## DS-K1T341A Series MinMoe Terminal Release Notes (2022-07-01)

<b>Device Model:</b> DS-K1T341AM DS-K1T341AMF	Firmware Version	ARM: ACS_641_AI3_EN_STD_V3.2.30_build220610 ACS_641_AI3_EN_NEU_V3.2.30_build220610
	SDK	Latest version
<b>Naming Rule:</b> M for M1 card, F for fingerprint	iVMS-4200 Client Version	Latest version baseline

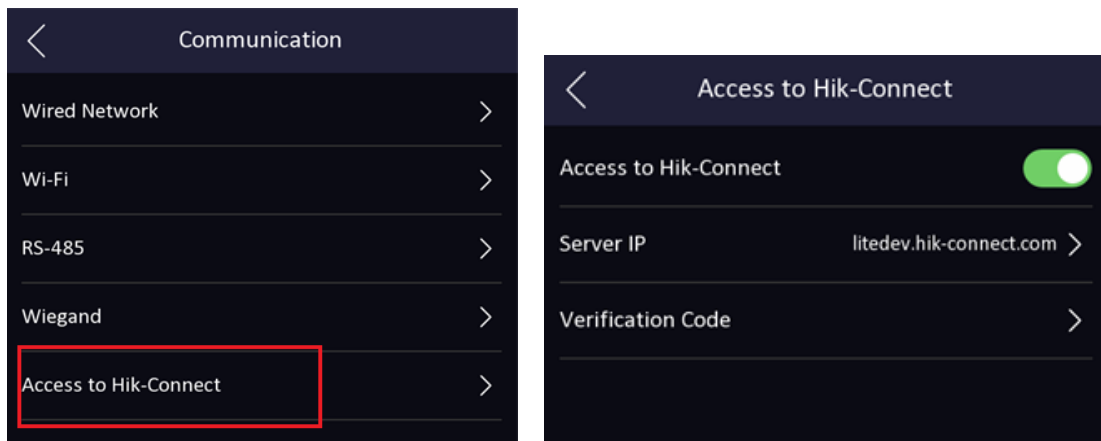
1. Add Hik-Connect menu in device UI Menu → Comm. The function is disabled in default.

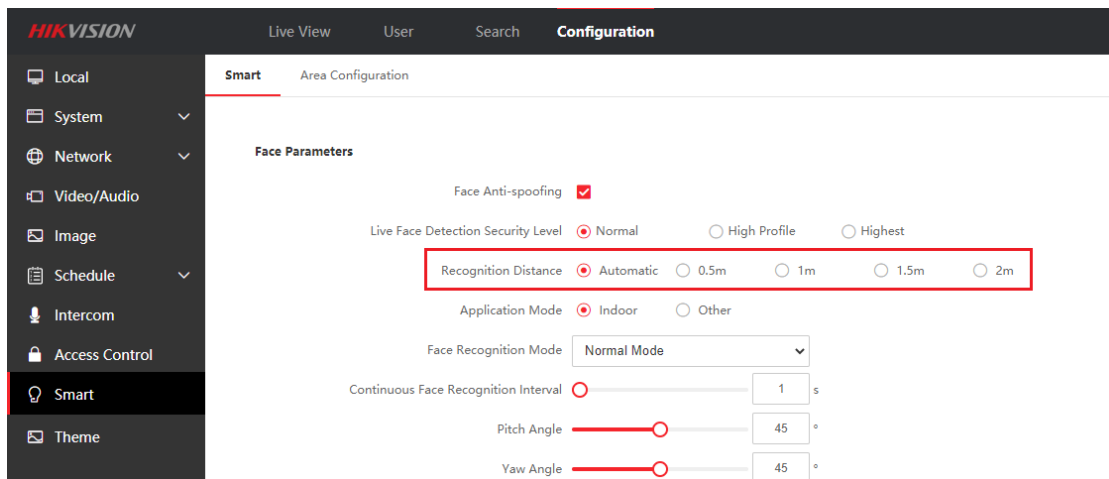
1. Optimize the wake-up distance of the device screen through the face, and the wake-up distance is consistent with the recognition distance
